Re: NPDES Permit No. IN0000205
Permit Modification
ArcelorMittal Indiana Harbor, LLC – West
East Chicago, Indiana
Lake County

AMENDED AUTHORIZATION TO DISCHARGE UNDER THE

ARCELORMITTAL INDIANA HARBOR LLC – INDIANA HARBOR WEST

National Pollutant Discharge Elimination System
FACT SHEET
for
ArcelorMittal Indiana Harbor, LLC – Indiana Harbor West
December 2014

Figure 1: Outfall Locations

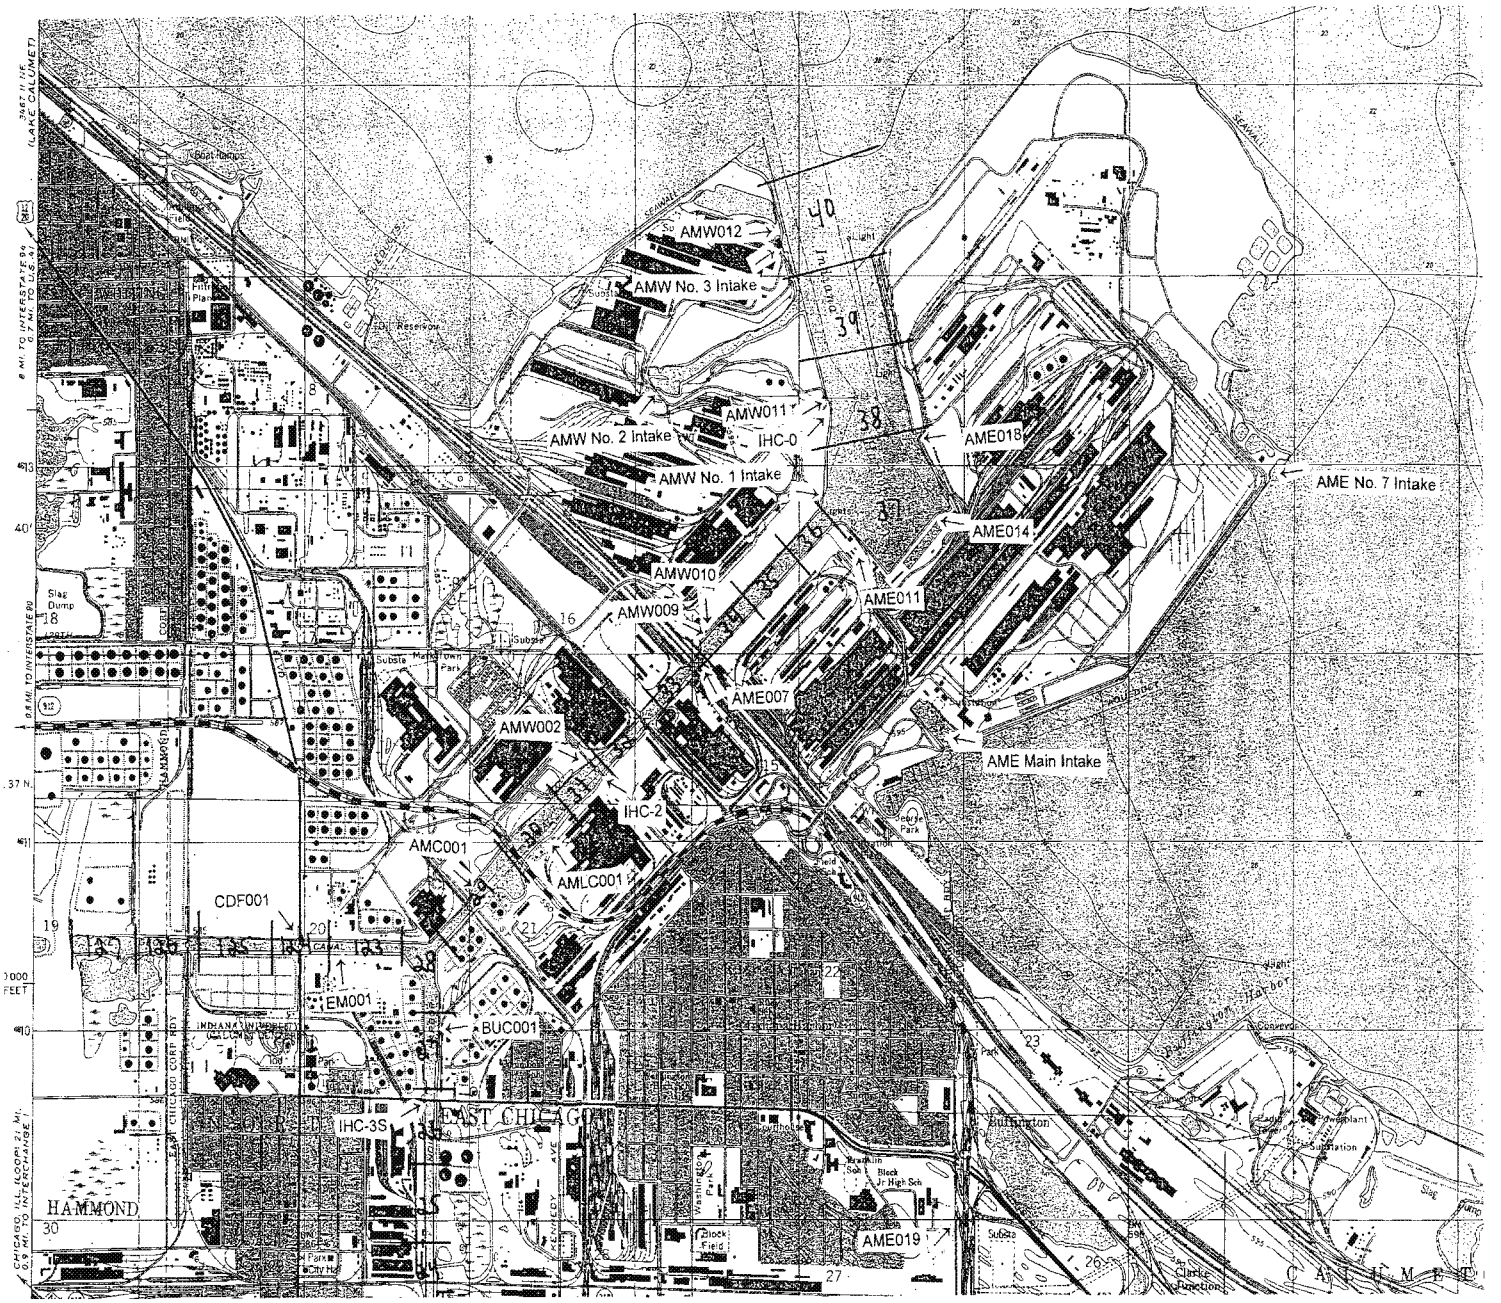
- The receiving stream, identified in Part I.A.8, has been changed from "Lake Michigan" to "the intake channel for the Nos. 2 and 3 water intakes". The facility has maintained since the draft of the December 2011 permit that the location of Outfall 012 is not to the open waters of Lake Michigan. The location of Outfall 012 is behind the break wall to the open waters of Lake Michigan where a long channel allows Intakes Nos. 2 and 3to withdraw water. Outfall 012 discharges to the fore bay of the No. 3 Intake. Furthermore, they have provided dye studies to show that at most, only 12% of the discharge flow from Outfall 012 bypassess the No. 3 water intake and discharges to the intake channel. A new definition of "open waters of Lake Michigan" was added to Indiana regulation at 327 IAC 2-1.3-2(30) in 2012 as part of the statewide antidegradation rulemaking. Based on the new definition, IDEM has determined that the discharge from Outfall 012 is not to the open waters of Lake Michigan. A map showing the location of Outfalls 012 (AMW012) in relation to the No. 3 Intake has been included as Figure 1.

IDEM conducted a new water quality assessment for Outfall 012 (Attachment A) based on a receiving stream identified as the intake channel for the Nos. 2 and 3 water intakes, using a reduced effluent flow and using additional effluent monitoring data collected since the permit renewal. As a result, vanadium and ammonia no longer showed a Reasonable Potential to Exceed (RPE) Indiana Water Quality Standards. Therefore, they were removed from Part I.A.8 of the permit.
